AGENDA – WORKSHOP OF THE CITY COUNCIL OF THE CITY OF PEARLAND, TEXAS, TO BE HELD ON JUNE 4, 2007, AT 7:00 P.M., IN THE COUNCIL CHAMBERS, CITY HALL, 3519 LIBERTY DRIVE, PEARLAND, TEXAS.

SUBJECT: Informal Workshop regarding proposed Planned Development (PD) on North Main Street.

EXECUTIVE SUMMARY

Map of Subject Property

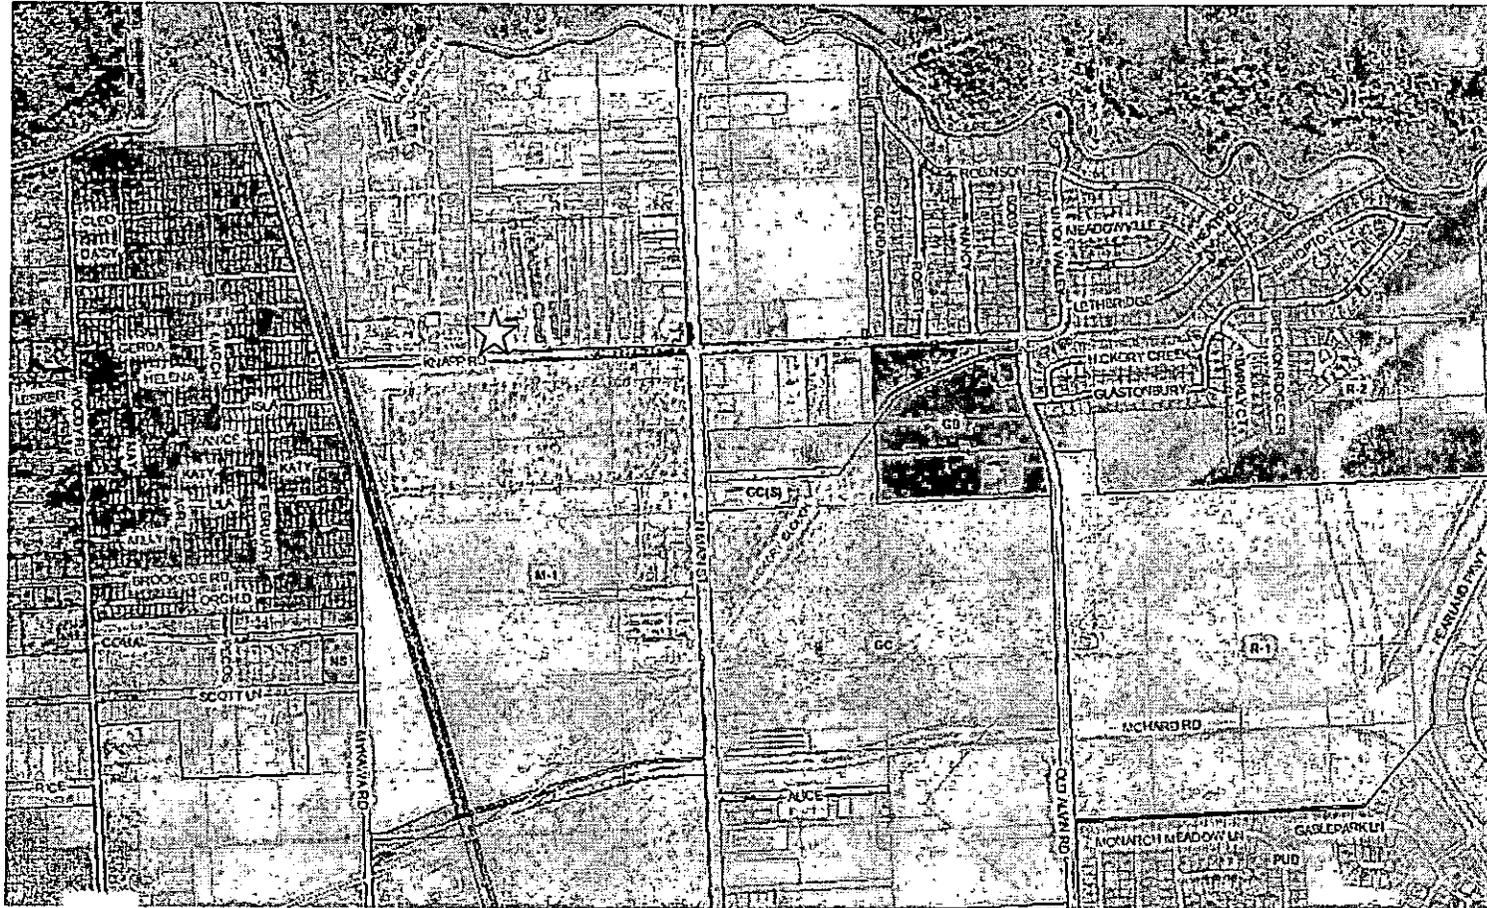
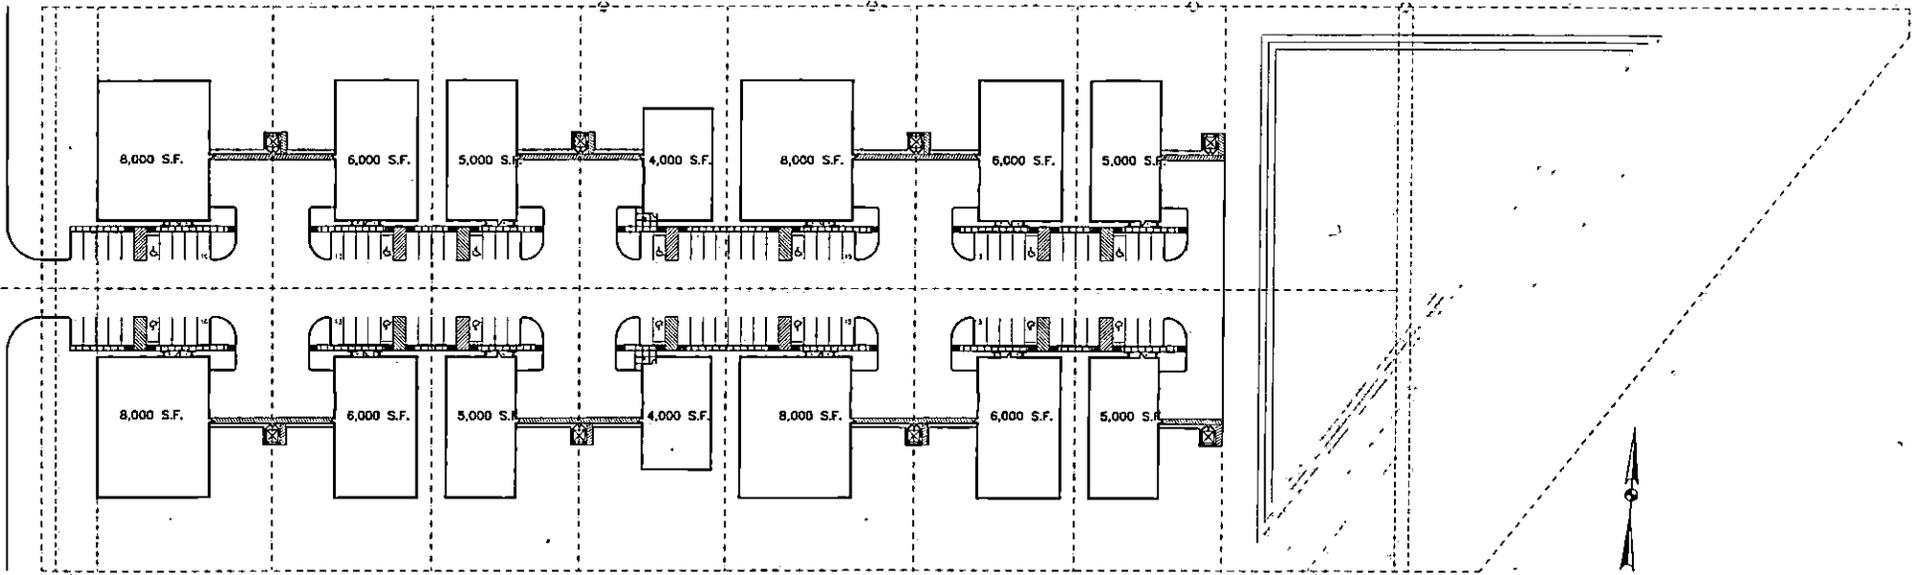
1. Uses, lot sizes, and areas – Staff does not have any concerns.
2. Five foot landscaped buffer along North Main Street instead of 30'. Staff recommends compliance with Corridor Overlay District (COD) standards and a 30' buffer.

3. Proposed landscaping is less than that required by the UDC. Staff recommends that all the lots in the PD be subject to the COD requirements in terms of landscaping.

4. Minimum required rear building setbacks are proposed to be 10' while the required is 20'. Staff recommends compliance with 20'.
5. The proposed parking ratio of 1.2 per 1000 sq. ft. is very low for retail and office uses that require 1 per 200 sq. ft and 1 per 300 sq. ft respectively. Staff recommends that parking conform to the UDC guidelines for each use or a multi occupancy ratio of one per 200 sq. ft. Warehouse requires 1 per 2000 sq. ft.

6. Section g.2. – Applicant is proposing crushed rock for certain areas. UDC requires paving with an all weather surface for all parking, driveways and loading/unloading areas. Crushed rock is not considered all-weather and staff is not in favor of crushed rock as proposed.

7. Five feet as proposed for landscaping strips does not meet the 6' requirement of the UDC. Staff recommends compliance with UDC and 6' wide landscaped strips.

8. Section k. – Five foot wide sidewalks proposed along Main Street. Staff recommends 6' wide sidewalks in conformance with UDC.

1. Base zoning needs to be specified as GC or other under Section II.2 in the PD document.
2. The Land Use Summary table is incomplete. This table is not required in the PD.

3. It is not clear if each lot would meet the requirements of the GB zone. This needs to be clarified.
4. The UDC requires a PD plan that is specific and not conceptual. This needs to be clarified.

5. Define “non-heavy” truck under parking design, location and use.
6. Parking islands and aisles need to meet the requirements of the UDC. The sizes and width need to be specified if not in compliance with UDC.

7. Section f.6 – “Additional parking may be added in driveway or joint ingress areas provided that they run 90 degrees from side ___” – not clear. The aisles need to be left clear for emergency / fire access.

8. Section g.3. – All storage needs to be screened as per the UDC. The term “orderly storage” needs to be clarified.
9. Section h. – All refuse containers need to meet the UDC and COD requirements.

10. Section l. – Exterior design should meet all the requirements of the UDC including Façade requirements. Staff recommends that all details regarding design, building height, roof design, fence design, canopy, cantilever, signage etc. be removed from the PD.
